VWC3 Third Submittal Response

PROJECT: Village at Westerly Creek III (DA-1639-01, Case # 2009-4001-02)

Below are my responses to the Second Submission Development Review comments.

Re: Second Submission Review – Villages at Westerly Creek Phase 3 – Site Plan – Comment Response

SHEET TITLE: SITE PLAN

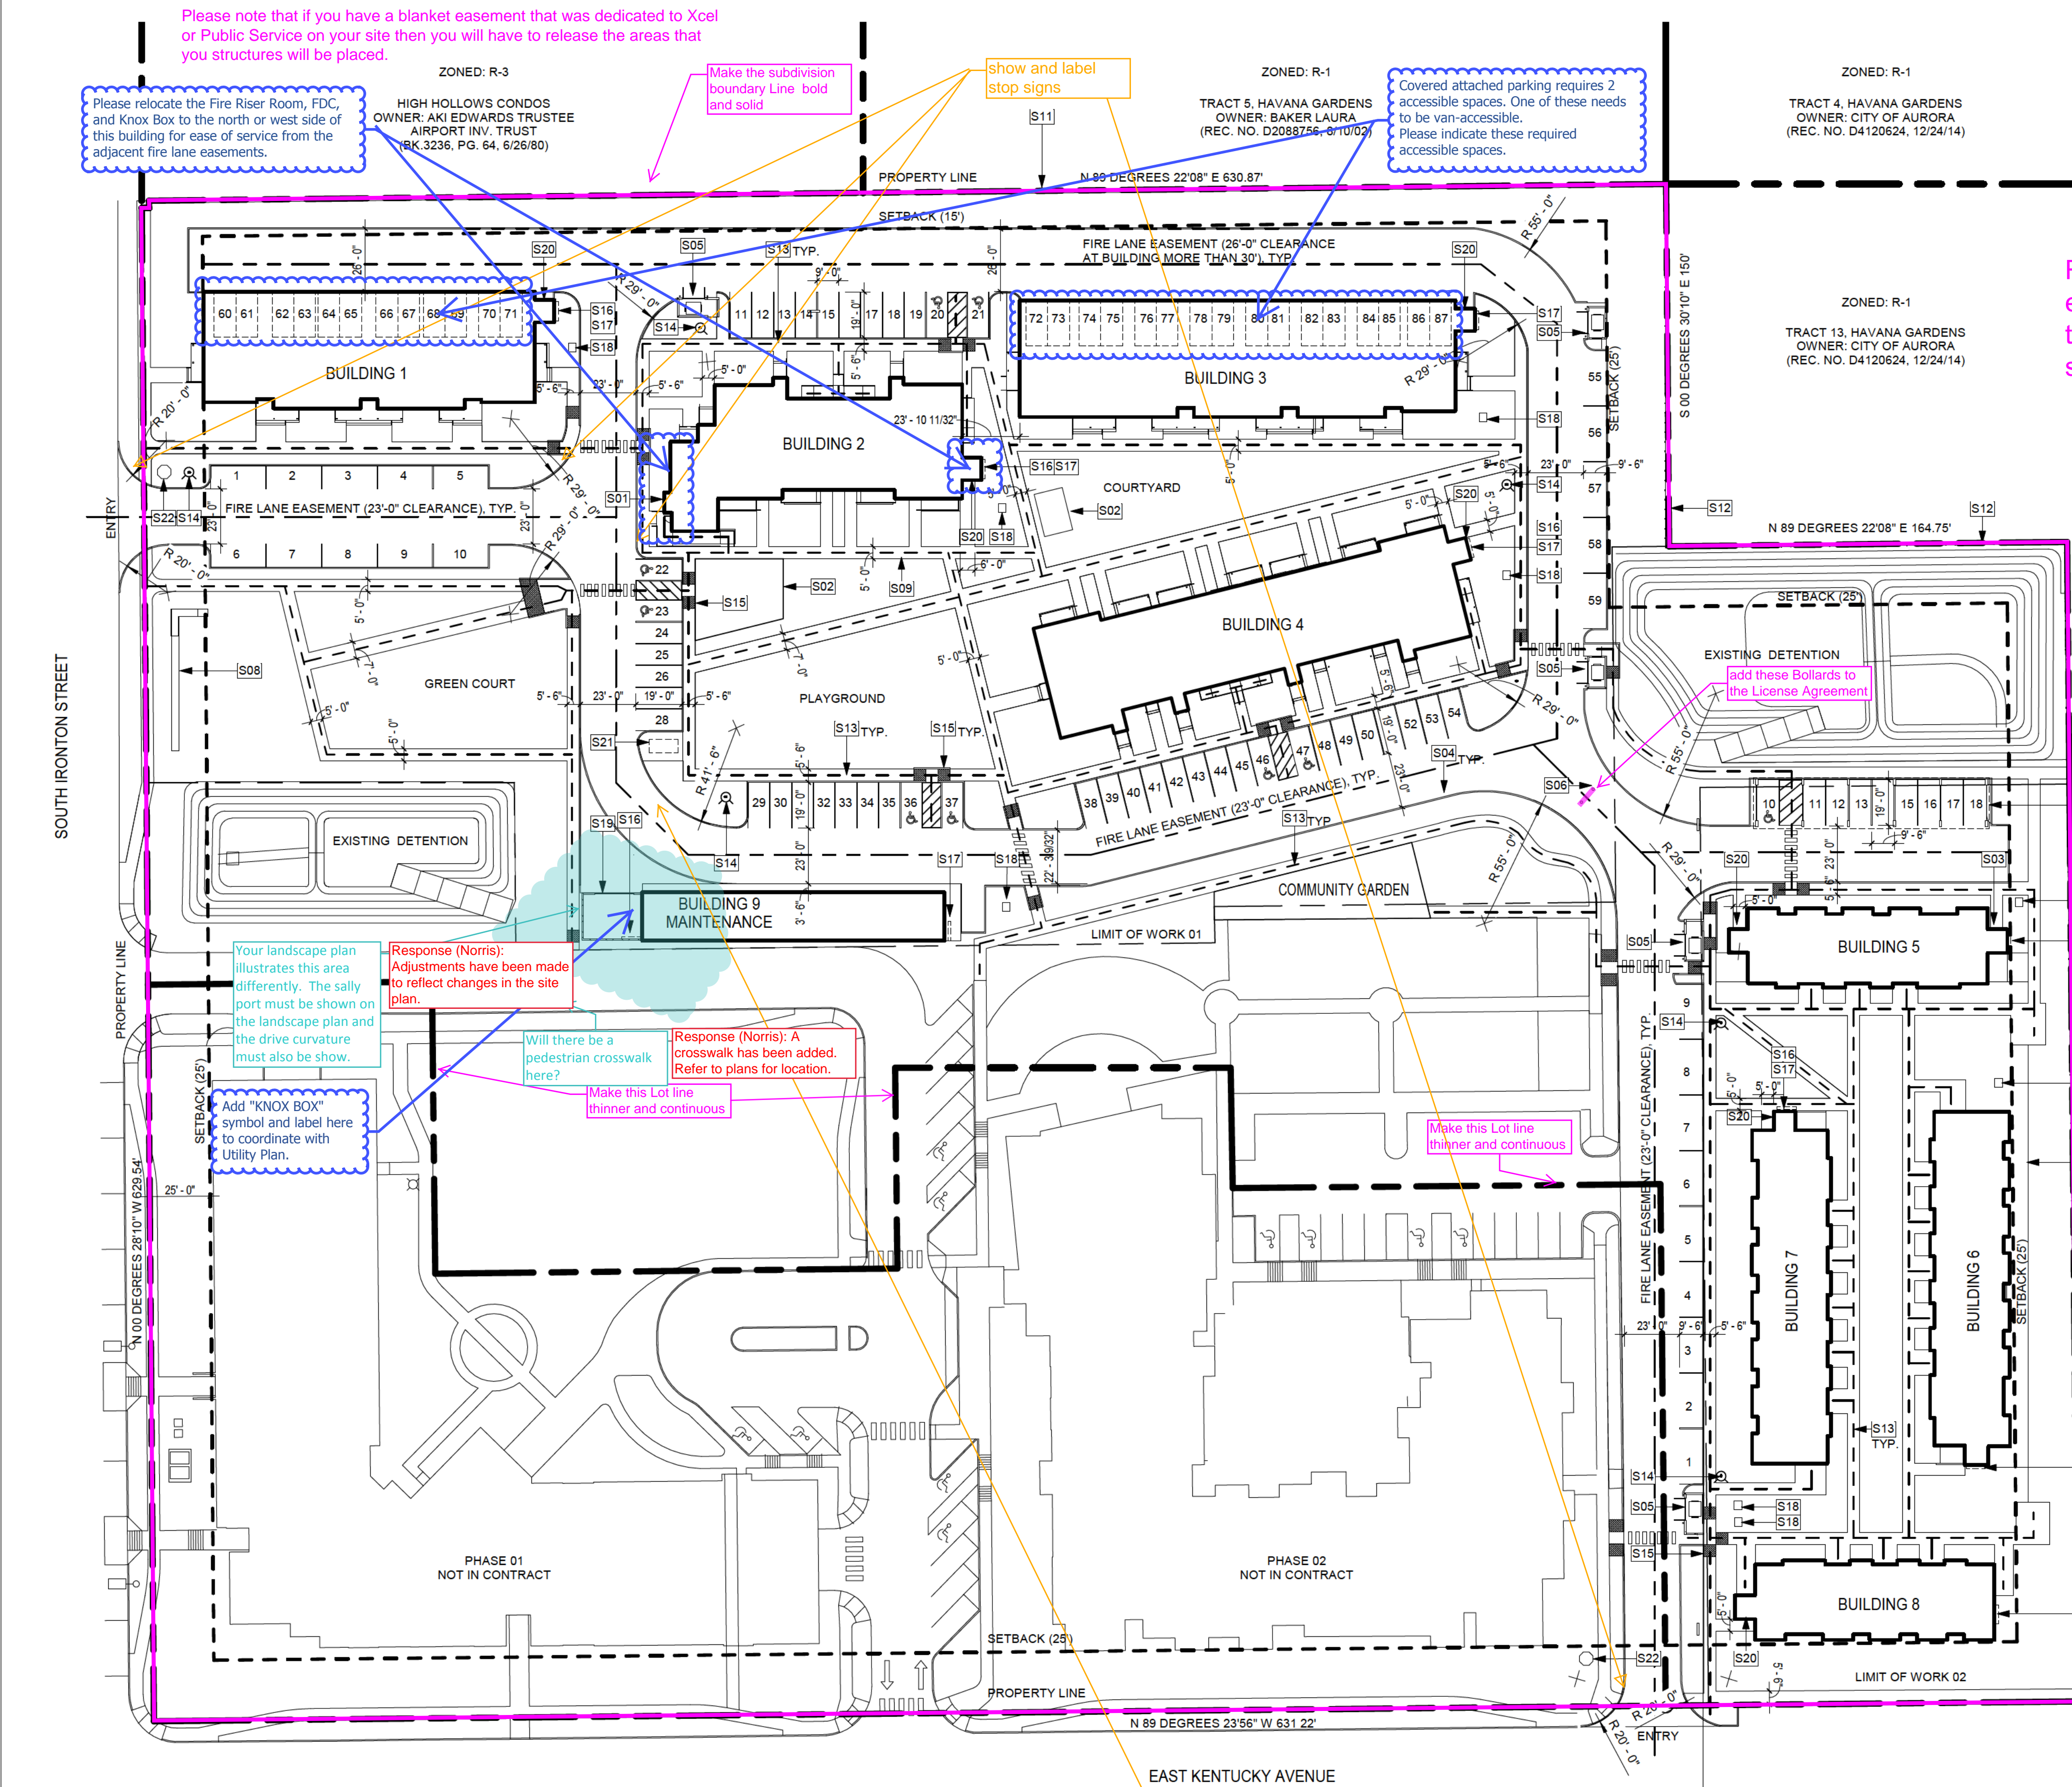
REPLACE THIS NOTE WITH:
MULTI-FAMILY DEVELOPMENTS WHERE THE NUMBER OF DWELLINGS EXCEEDS 100 SHALL BE PROVIDED WITH SEPARATE AND APPROVED FIRE APPARATUS ROADS... (2015 IFC D106.1). THEY SHALL BE PLACED A DISTANCE APART EQUAL TO NOT LESS THAN ONE-HALF OF THE LENGTH OF THE OVERALL MAXIMUM DIMENSION OF THE PROPERTY OR AREA TO BE SERVED, MEASURED IN A STRAIGHT LINE BETWEEN ACCESSES. (2015 IFC D106.3)

LANDSCAPE PLAN

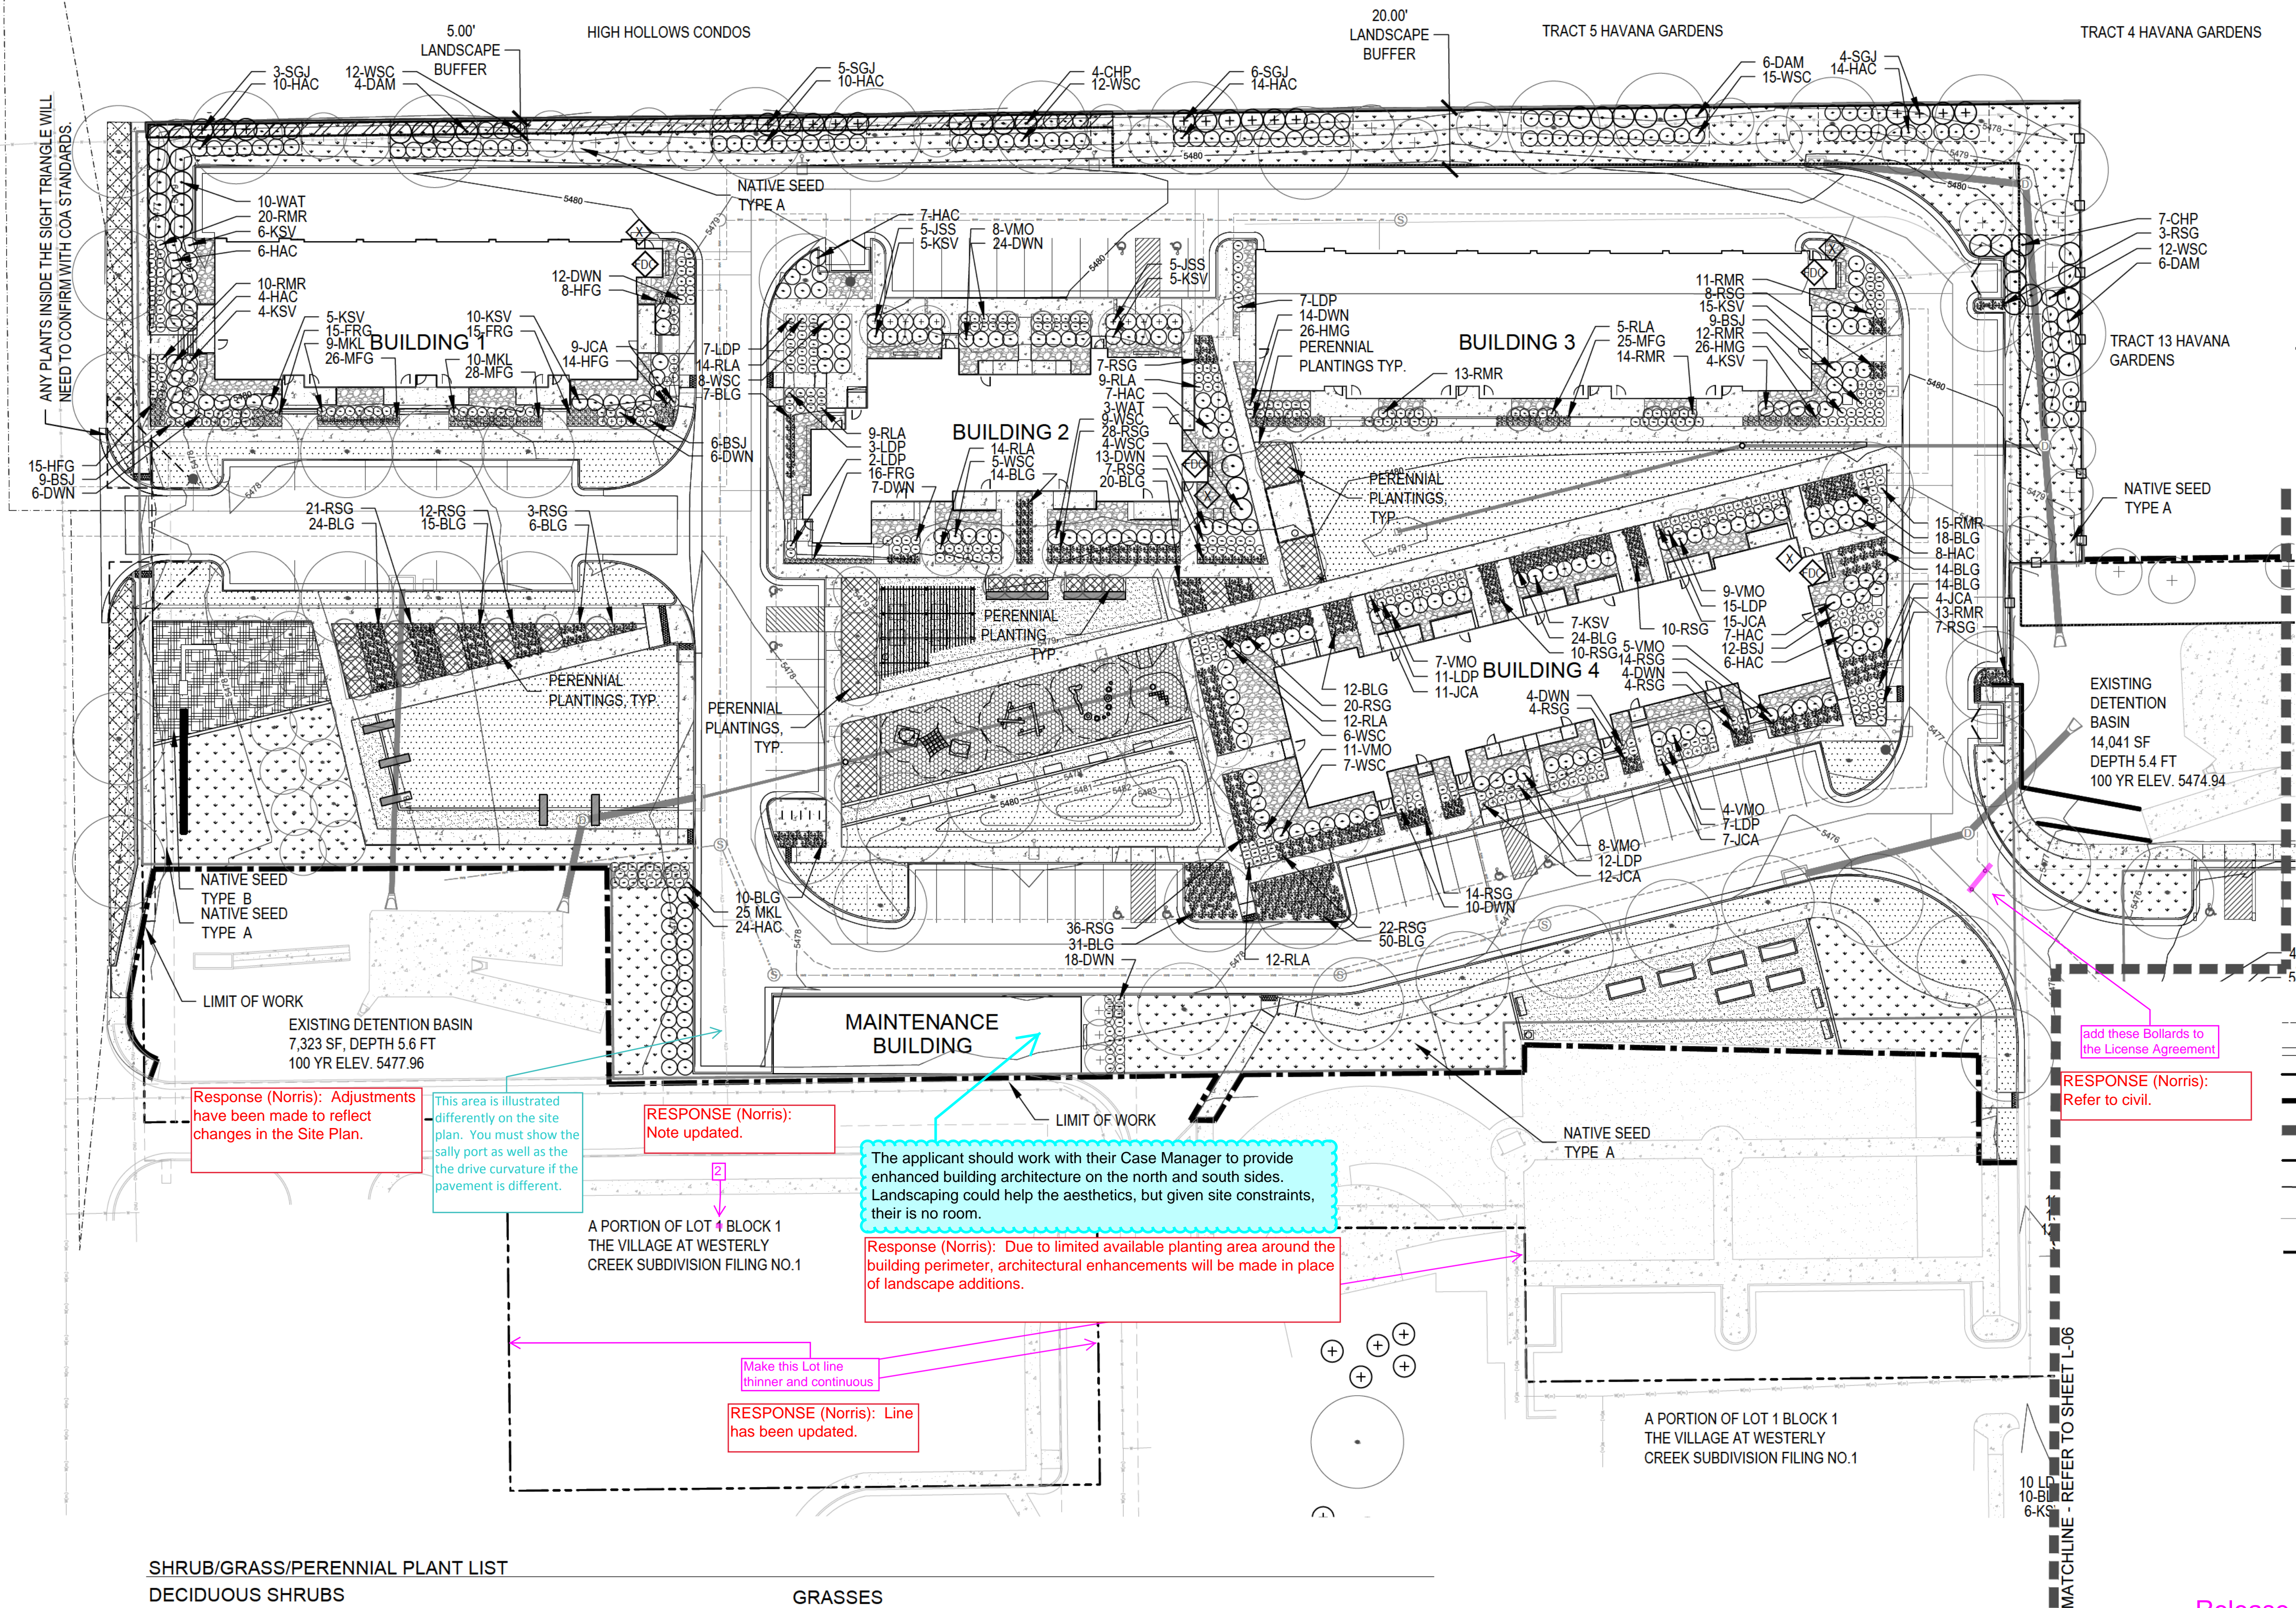
Update LS plans per site plan - this roadway crossing has been removed

This area is illustrated differently on the site plan. You must show the sally port as well as the drive curvature if the pavement is different.

these bollards will need to be in the License Agreement
Response (Norris): Please refer to Civil.

Release the existing easements and dedicate the new easements shown here
Response (Norris): Please refer to Civil.

Response (Norris): Adjustments have been made to reflect changes in the Site Plan.

Response (Norris): Adjustments have been made to reflect changes in the Site Plan.
